RIVERBEND WIND ENERGY FACILITY

Exhibit A-1.6 CHANGES

EXHIBIT A-1.6 – CHANGES

FIGURE 1C – N169-5.X - SUBSTATION
PREDICTED SOUND CONTOUR MAP
(1X MPT ALTERNATIVE)

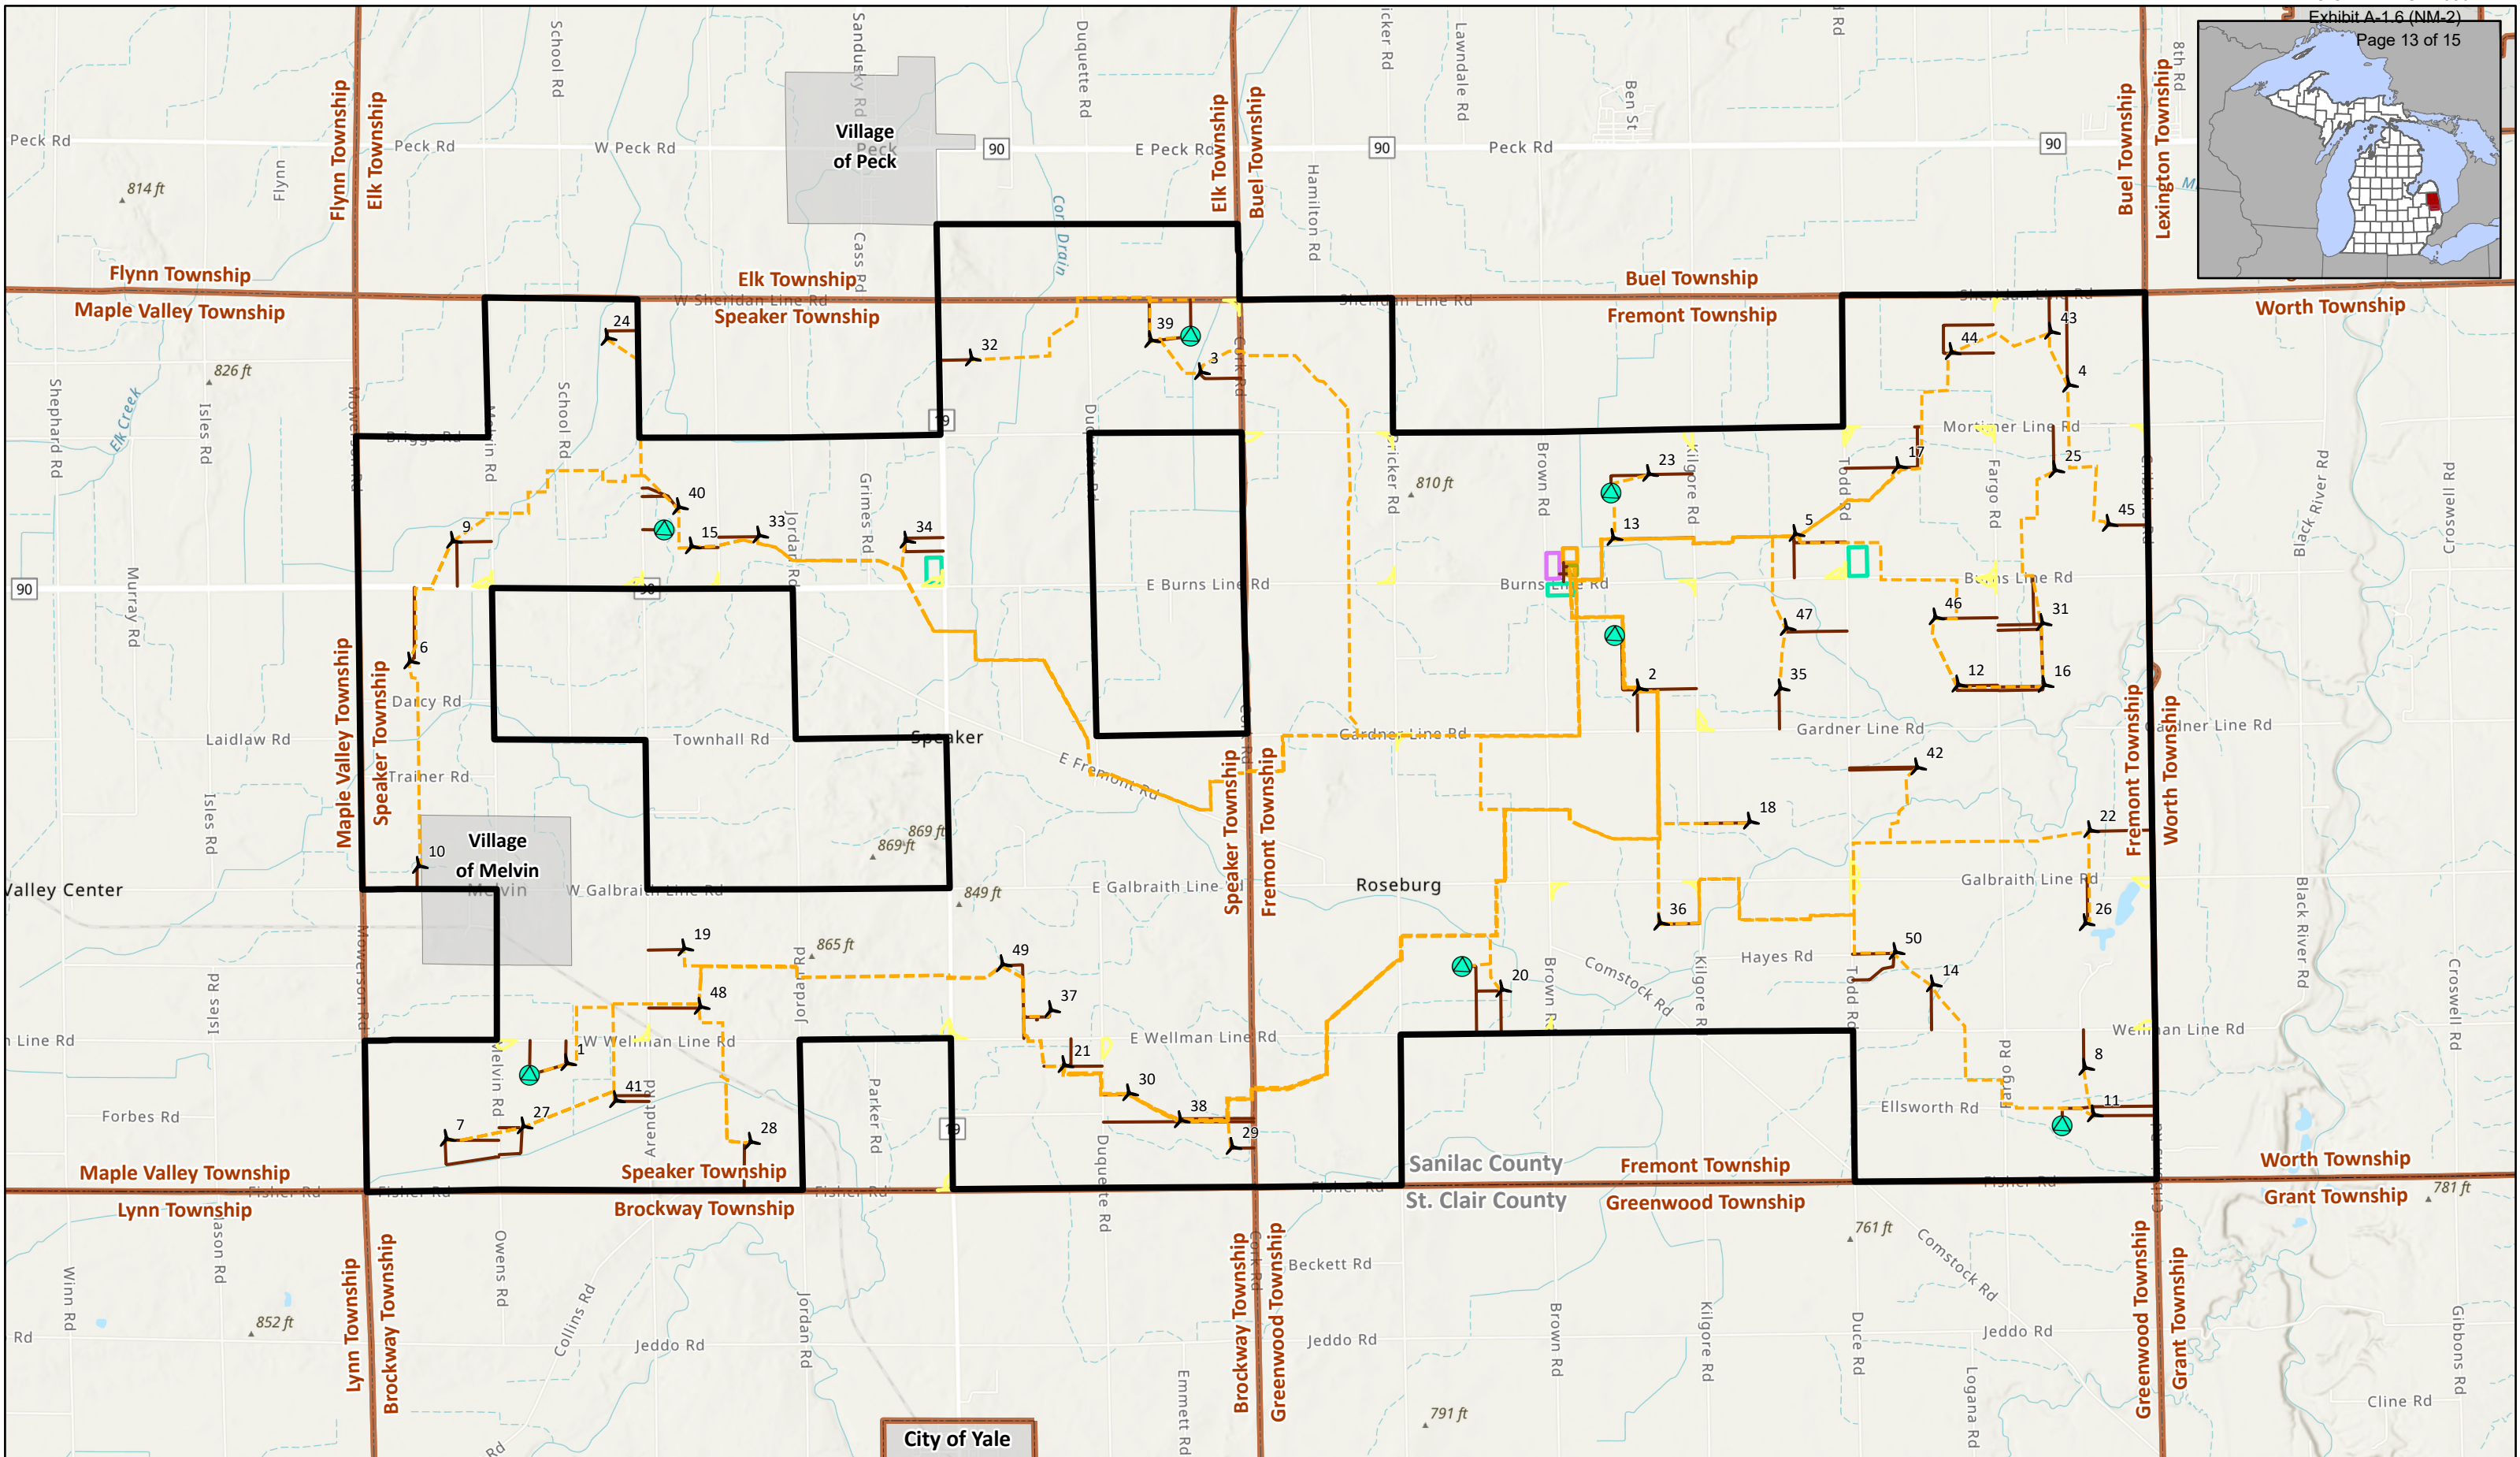
- Main Power Transformer - The Project design currently includes two transformers in the substation; however, in place of the pair, a single, larger transformer is an option under consideration. In support of this potential change, an additional noise analysis was performed, which concludes that if the change is made, the predicted noise levels remain compliant with the statutory noise limits. Refer to **Exhibit A-1.7** for the additional study. Refer to **Figure 1A – V162-7.2 - Substation Predicted Sound Contour Map (1x MPT Alternative)**, **Figure 1B – V163-4.5 - Substation Predicted Sound Contour Map (1x MPT Alternative)** and **Figure 1C – N169-5.X- Substation Predicted Sound Contour Map (1x MPT Alternative)** for a depiction of the sound isolines related to this technology change.

FIGURE 2 – PROJECT LAYOUT

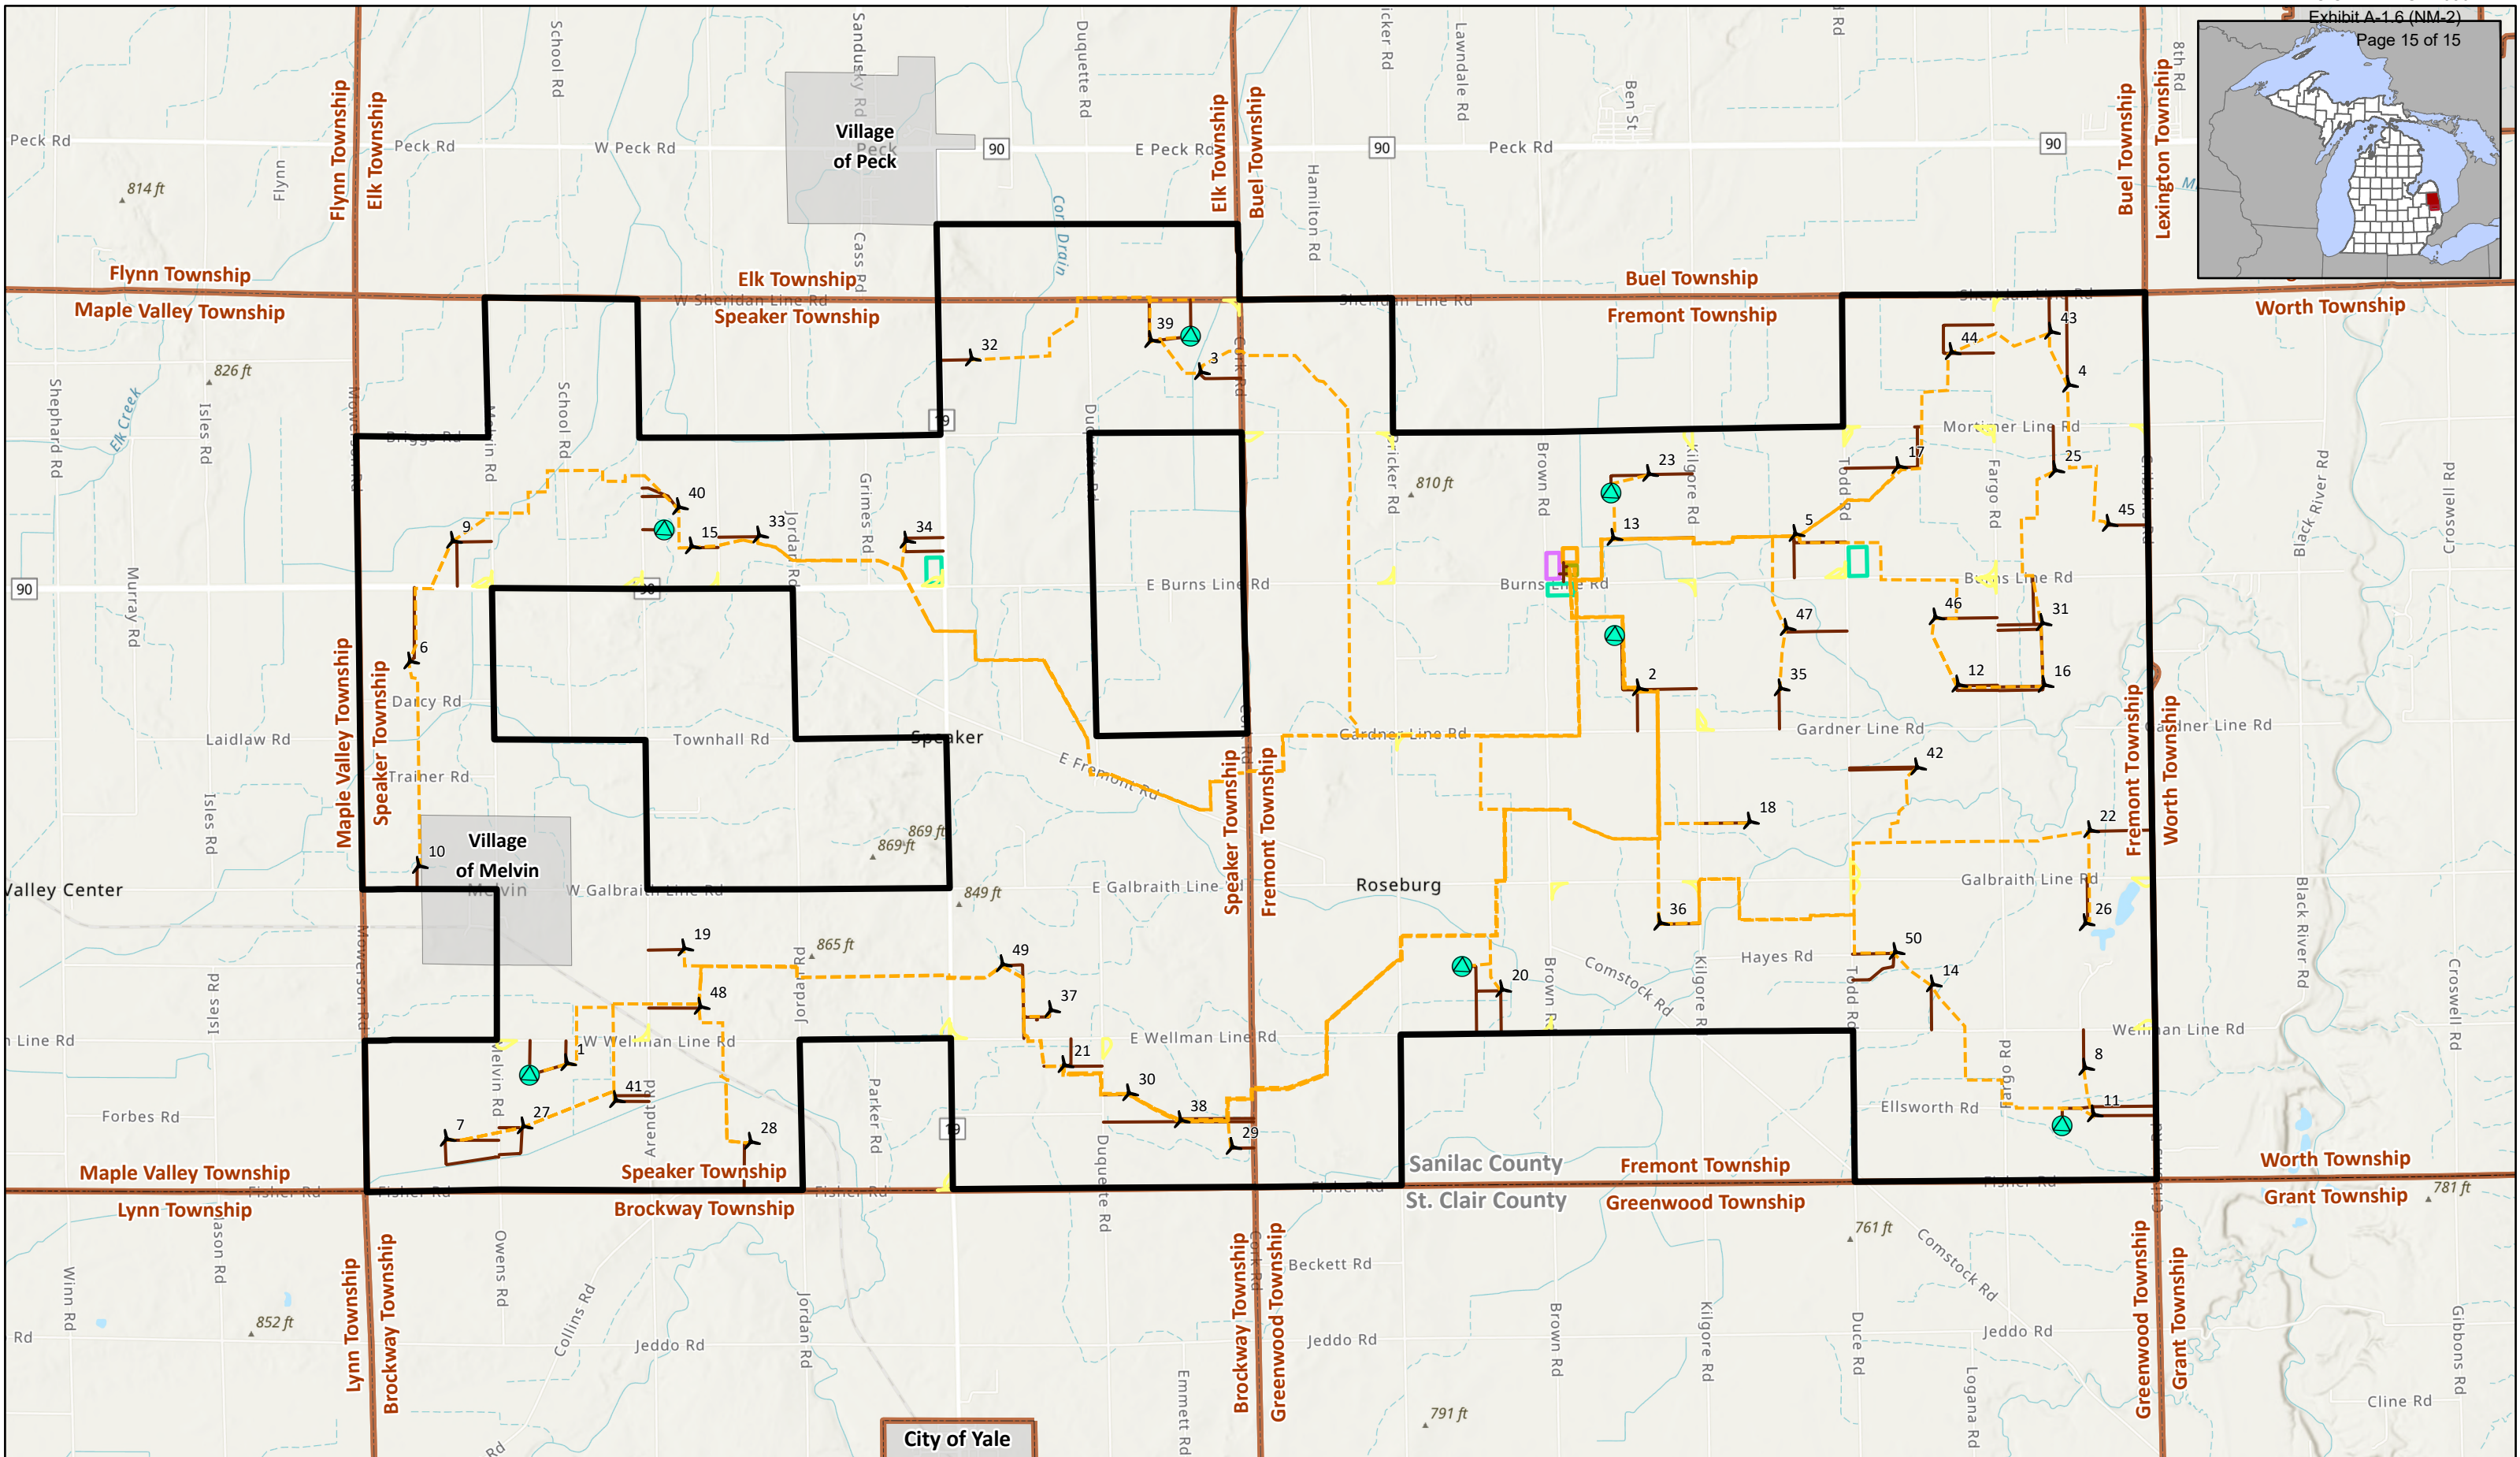
- **Access Roads** – There is a potential for minor changes to access roads with ongoing considerations including, but not limited to, landowner input, cost considerations and design optimization. Known access road options are currently displayed in **Appendix 1.1-A – Project Layout of Exhibit A-1.1**.

- **Collection Routes** – There is potential for minor changes to collection routes with ongoing considerations including, but not limited to, landowner input, cost considerations, and design optimization. Known collection route options are currently displayed in **Appendix 1.1-A – Project Layout of Exhibit A-1.1**.
